Project	IEEE 802.16 Broadband Wireless Access Working Group < http://ieee802.org/16 >	
Title	Examination of proposed interference resolution techniques and messaging for IEEE 802.16h & additions to working document 802.16h-05_022	
Date Submitted	2005-11-10	
Source(s)	John Sydor, Shanzeng Guo Communication Research Center 3701 Carling Ave Ottawa, ON, Canada, K8H 8S2	Voice: (613) 998-2388 Fax: (613) 998-4077 { jsydor , sguo }@ crc.ca
Re:	Call for Contribution, "IEEE 802.16's License-Exempt (LE) Task Group", 2005-10-17 Item 4.	
Abstract	This document contains additions to the draft IEEE802.16h working document and raises some questions about the efficiency of currently proposed approaches to interference resolution as outlined in the subject working draft document. The sections and paragraphs given below refer to those of the subject working draft document IEEE802.16h-05/022. All direct additions to the working document are given in italic font and included below

Examination of proposed interference resolution techniques and messaging for IEEE 802.16h & additions to working document 802.16h-05_022

John Sydor, Shanzeng Guo

Communications Research Centre, Ottawa, Canada

Figure 1 Discovery Process

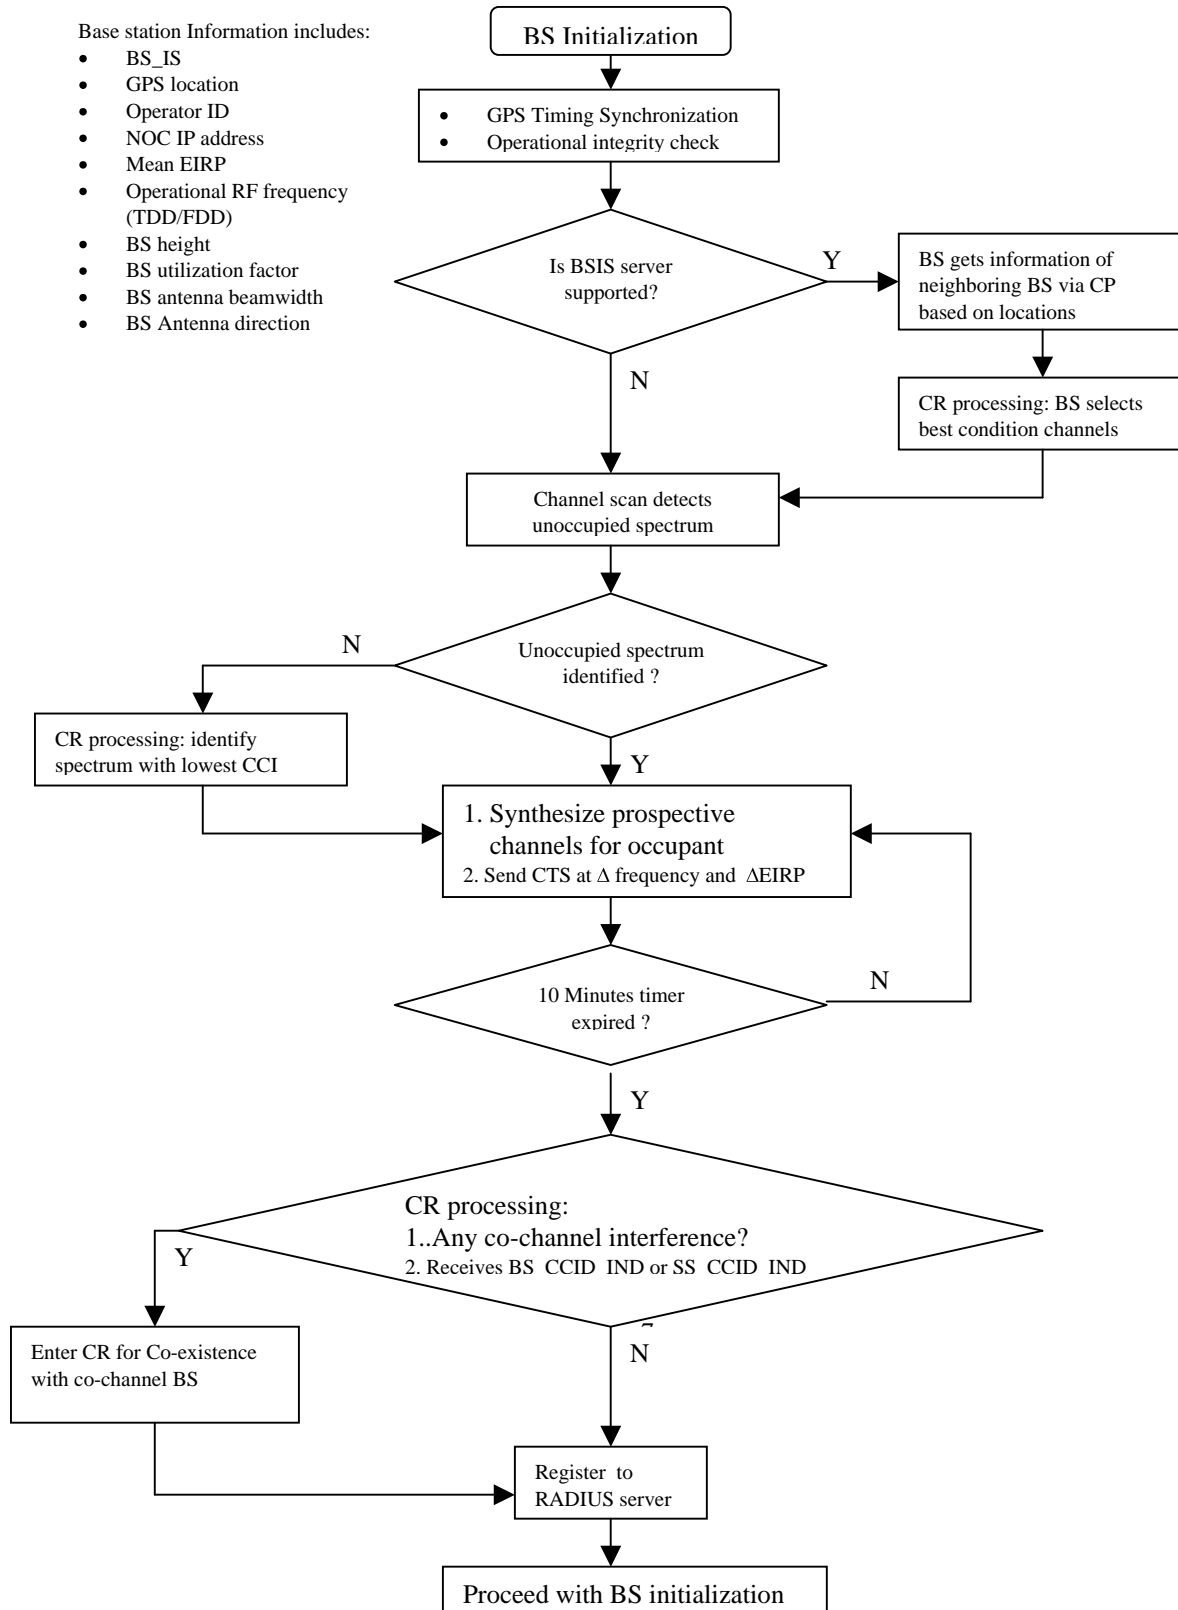
A newly entering BS, prior to establishing a network will undertake the following entry steps as shown in Figure 1.

- *On initialization, the Base Station will derive a GPS 1pps timing reference and the UTC time stamp.*
- *The BS will determine its GPS location.*
- *The BS will then check to see if it has the IP address of a remote database that will allow network discovery of other BS.*

- *IF an BSIS server or IP data base address exists, the BS will determine the GPS locations and IP addresses of all potentially interfered with stations. If no BSIS or database IP address exists, potentially interfered-with station are not known, but still can be present.*

- *The BS then undertakes a spectrum scanning process, searching over its intended coverage for zones of no occupancy. If occupancy exists, it will be graded by the CR processor associated with the base station. If all spectrum is empty, proceed to sending of CTS.*

- *CTS messages are sent at every opportunity for 10 minutes*
- *Responses in the form of BS_CCID_IND and SS_CCID_IND messages are received at the initializing BS and used for the coexistence protocol. If no responses are provided the initializing BS proceeds with registration of its IP address and GPS location with the “Radius” server or equivalent.*

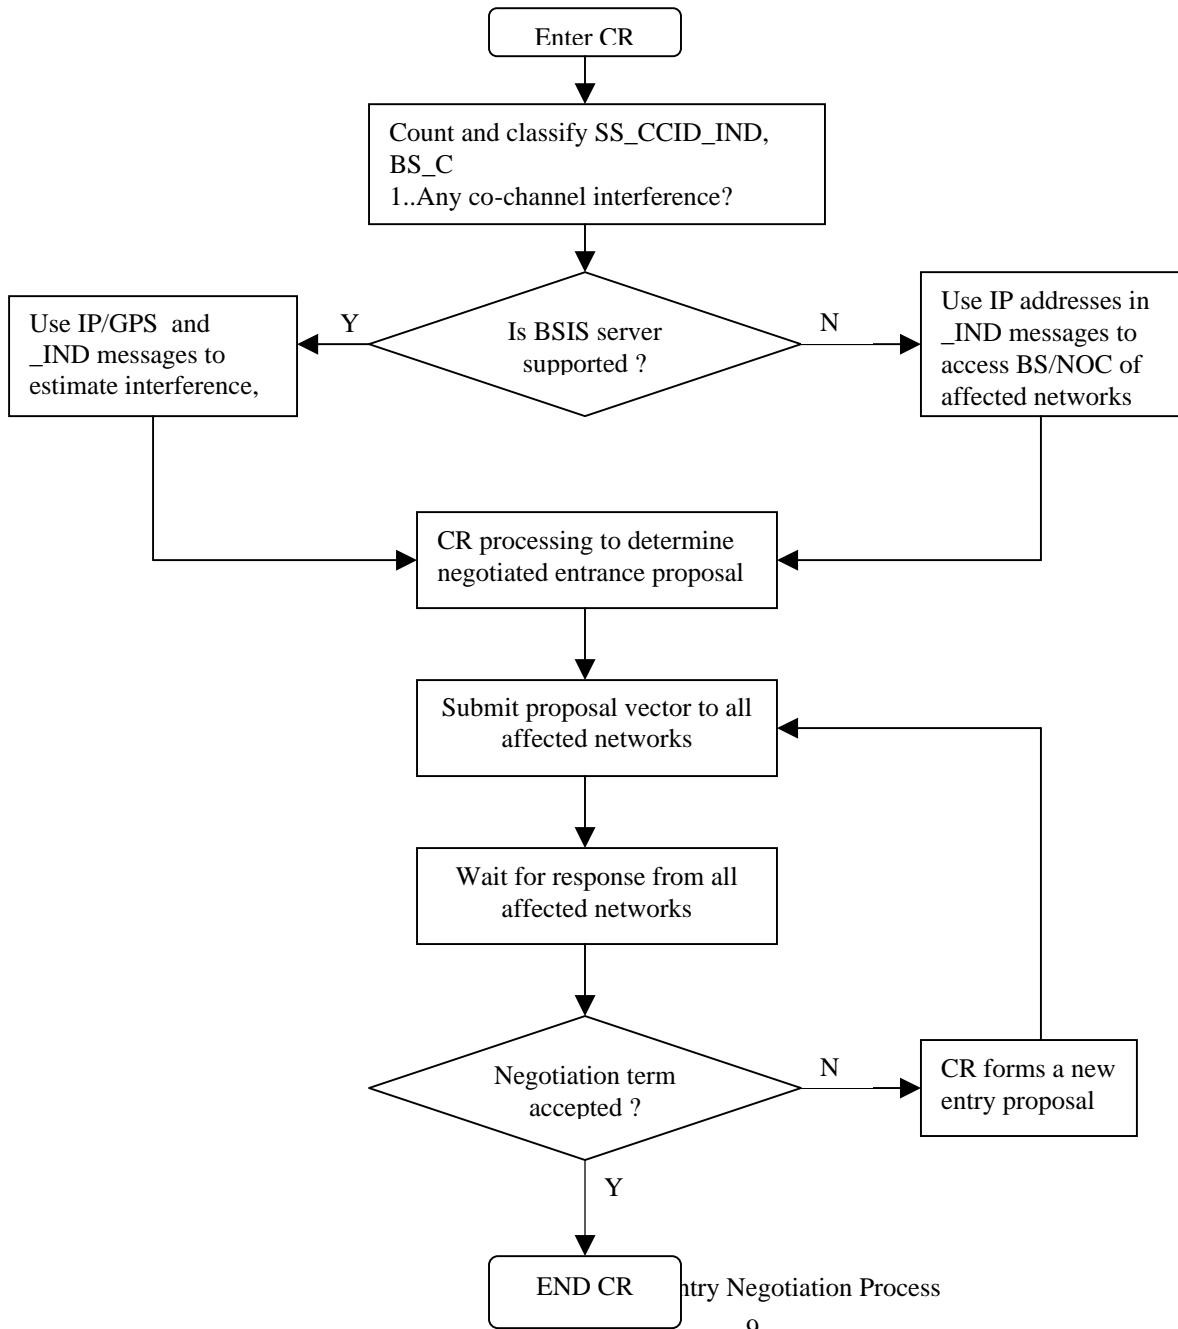
The CR negotiation protocol is shown in Figure 2. The salient features of the protocol are:

- *After the CTS discovery the _IND messages are counted and correlated with IP data/GPS location data of proximate BS. The Cognitive Processor at the initializing BS or the BS_NOC categorizes interference instances, conducts analysis for hidden nodes (ie, for networks which are proximate, but gave no responses) etc.*

- *The initializing CTS, having identified the community or proximate networks that it seeks coexistence with, communicates with the base stations (or their CR_NOCs) and initiates a process of information exchange in which the contacted networks provide the initializing network with details on their operation. This process will likely require some form of private key exchange to transport sensitive information.*

- *Information received by the initializing BS (BS_NOC) is then used to create a “negotiation vector”, which is really a submission, or series of submissions to the base stations with which coexistence is sought. The transaction occurs at the TCP/IP layers. The operating BS examine the effects of the “negotiation vector”*

- *Operating BS either accept the proposal or reject it. The process is undertaken until a coexistence scheme can be rationalized whereby space, time, and coverage area are negotiated for use in manner favorable to all networks. Once agreement is reached, operating and initializing BS configure their operation for the new ad-hoc topology and community.*
